**PLANNING COMMISISON
SITE PLAN WAIVER REQUEST REVIEW SHEET**

CASE NUMBER: SP-2020-0364C **PC HEARING DATE:** March 23, 2021

PROJECT NAME: Lessin Lane Villas

URBAN ATX CLIENT LESSIN LANE VILLAS SITE DIMENSION CONTROL

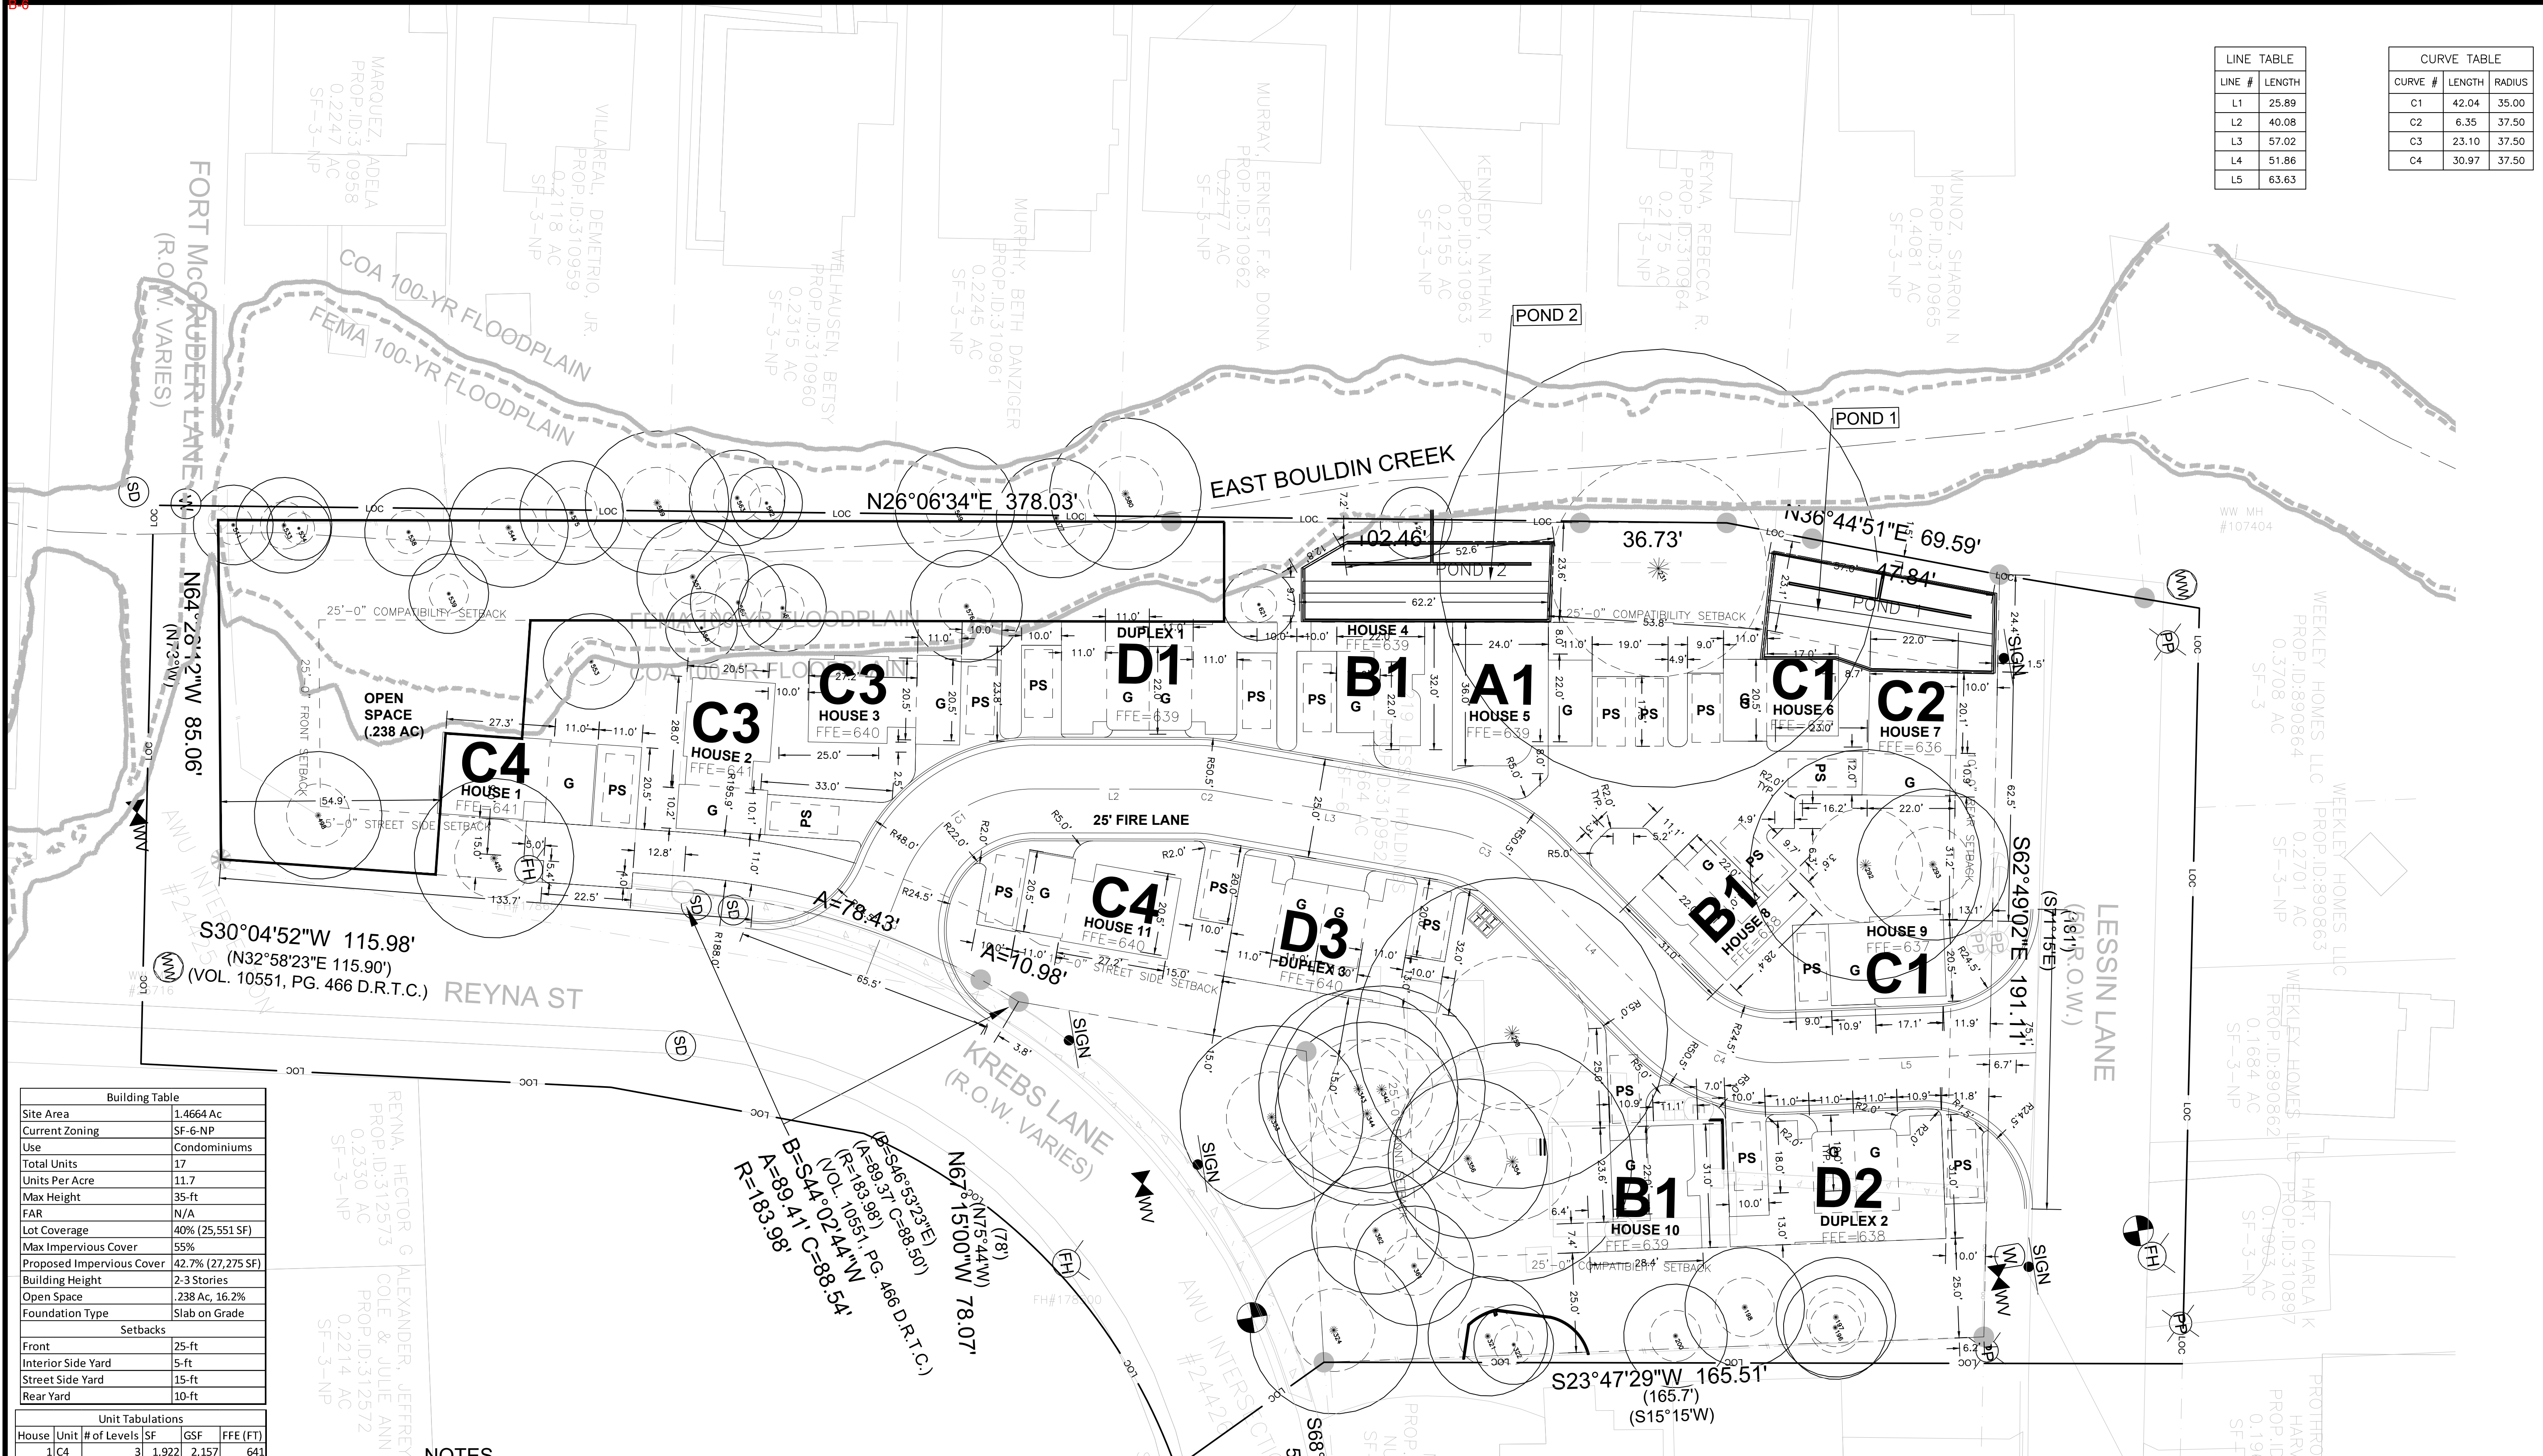
The applicant is requesting a waiver from § 25-2-1063. The site is subject to a 25' compatibility setback. The proposed development is encroaching into the compatibility 25' setback on the west property line for detention and water quality ponds. The ponds are more than 5' from the property line but within the 25'.

We request that the detention and water quality ponds be allowed to be constructed on the west side of the property bordering West Bouldin Creek adjacent to the 100-yr floodplain in the compatibility setback more than 5-ft but less than 25-ft from the property line . This location is ideal for the ponds due to the proximity to the flood plain. The outfall structure will discharge directly into the creek and have no adverse effects. The ponds are not large and will be shielded from view due to the existing trees and brush.

Ms. Avila, I have concerns if allowing this group to build retention ponds inside the 25' setback. Won't this easily cause more flooding and pollution in the creek that sits in the setback? All these clowns care about is how many units they can stuff inside the project to make more money. My properties have been in my family for over 90 years and hate to see the neighborhood heading in this direction.

Staff recommends approval of the compatibility setback waiver request. All proposed units are not within the setback. The site complies with all other compatibility standard requirements, such as lighting, screening, and building heights.
